a written submission by way of objection to DA 2019/1463 & BC 2019/0284

RE:
DA 2019/1463 & BC 2019/0284
Address: 95 Gurney Cr., Seaforth

WRITTEN SUBMISSION: LETTER OF OBJECTION
Submission - Symons

Appendix A: More Skillful Design

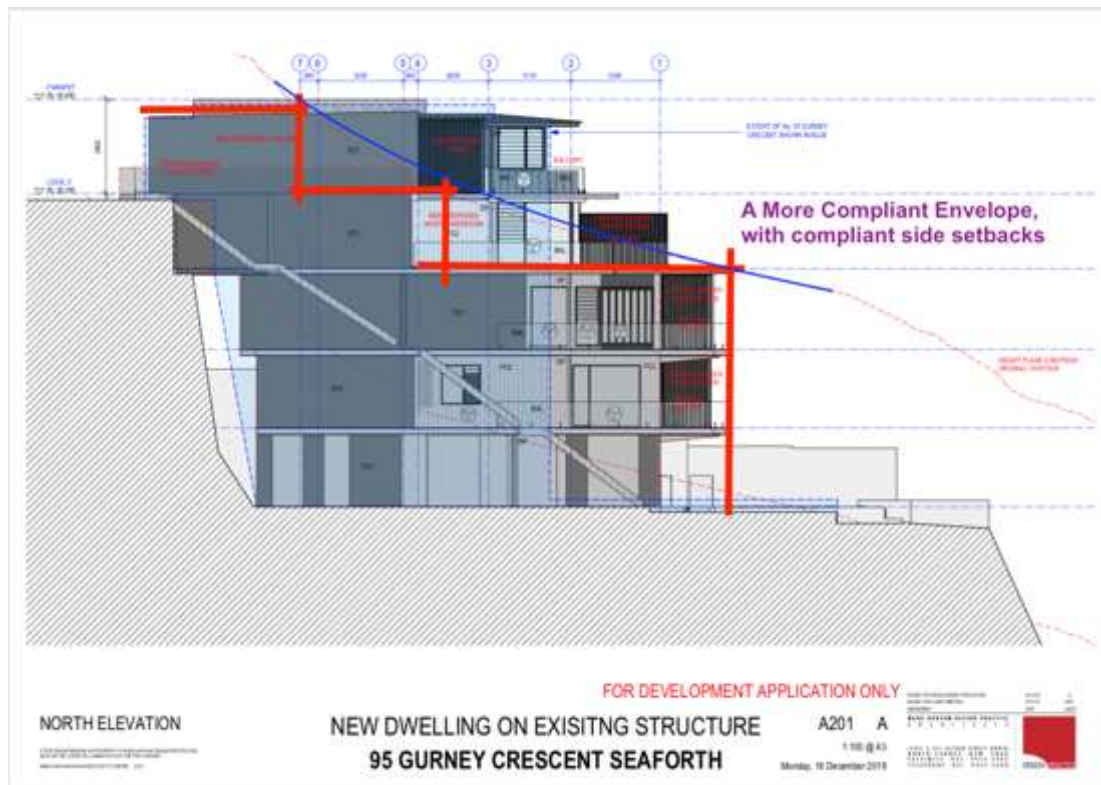
Plans showing a building envelope that delivers a general arrangement that provides a New Residence consisting 4/5 Bedroom + Study/Office + 3 independent Living Spaces + Pool.

A new stair to wrap around the proposed new lift.
